RESPONSE TO DEFERRAL AND AMENDED DEVELOPMENT APPLICATION

**47-55 GRAFTON STREET,
BONDI JUNCTION**

DA-155/2018

Figure 2 – Comparison Section showing 60m height plane

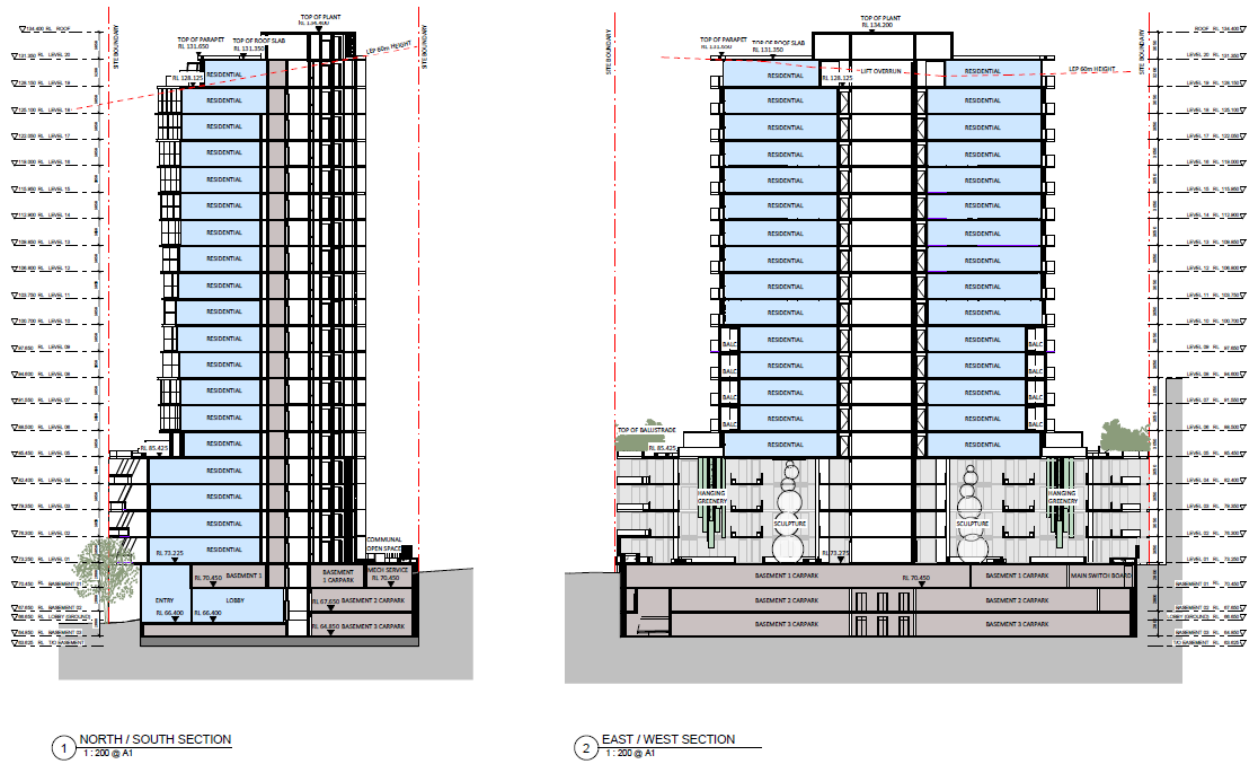
The bulk and scale of top of the proposed building have been significantly reduced to ensure that any variation to the height control relates only to non-habitable space. This accords with Council's most recent correspondence which noted that '*no habitable space is permitted to exceed the height development standard*'.

A comparison of the original and amended DA height non-compliance and built form, illustrating the significant reduction in bulk at the top of the building is provided at **Figure 1** and **Figure 2**.

The amendments to the overall design and rooftop have seen a slight increase in the overall height from 67.75m to 69.05m noting that this relates to the top of the plant which is located at the centre of the building. The original DA submission included two storey penthouses with the last floor being served by the lifts being Level 18 and the lift overrun at Level 19 with plant above this. In the amended proposal, the location of the Communal Open Space on Level 19 requires lifts to serve this level with the overrun extending to Level 20. Plant is still required over the lift overrun due to the reduced plant space on Level 19.

The structures that exceed the 60m height standard are setback from the sides of the building and are limited to communal open space, lift cores (providing equitable access to the communal open space), plant and servicing.

Figure 3 – Comparison of original & amended Grafton Street Photomontages

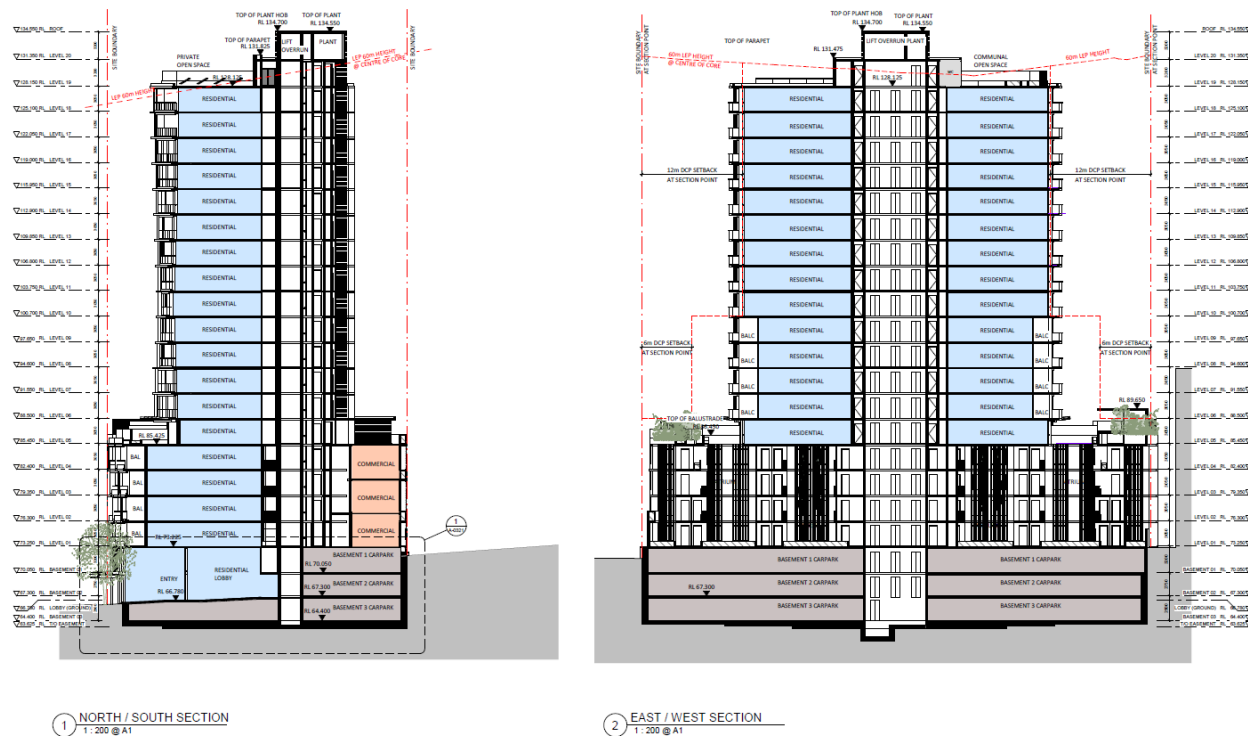
Figure 3 also provides a comparison of the original and amended façade when viewed from Grafton Street.
